Hi-Fi Products
Service Bulletin

Model: CDP-C70/C7ESD

No. 46

Subject: Malfunction of Program Play

Symptom:
(22)

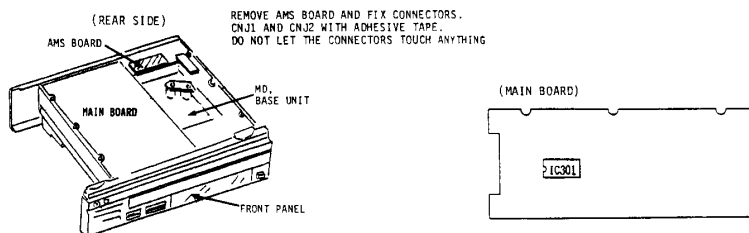
1. When selections have been programmed from more than one disc, the next selection on the disc, after the first disc is finished, is not played.
2. When programming more than 10 selections, the unit goes into pause between the 9th and the 10th selections.

Solution: Replace IC301 with the new type.

Ref. No.	Part Name	Part Number
Former	IC301	HD6301YOE75P	8-759-320-50
New		HD6301YOG31P	8-759-321-16

1. For CDP-C7ESD (U) Serial No. 800,001-803,000
CDP-C70 (U) Serial No. 800,001-812,000
replace IC301 with new type.
2. For CDP-C7ESD (U) Serial No. 803,001-803,500
remove AMS board and replace IC301 with new type.
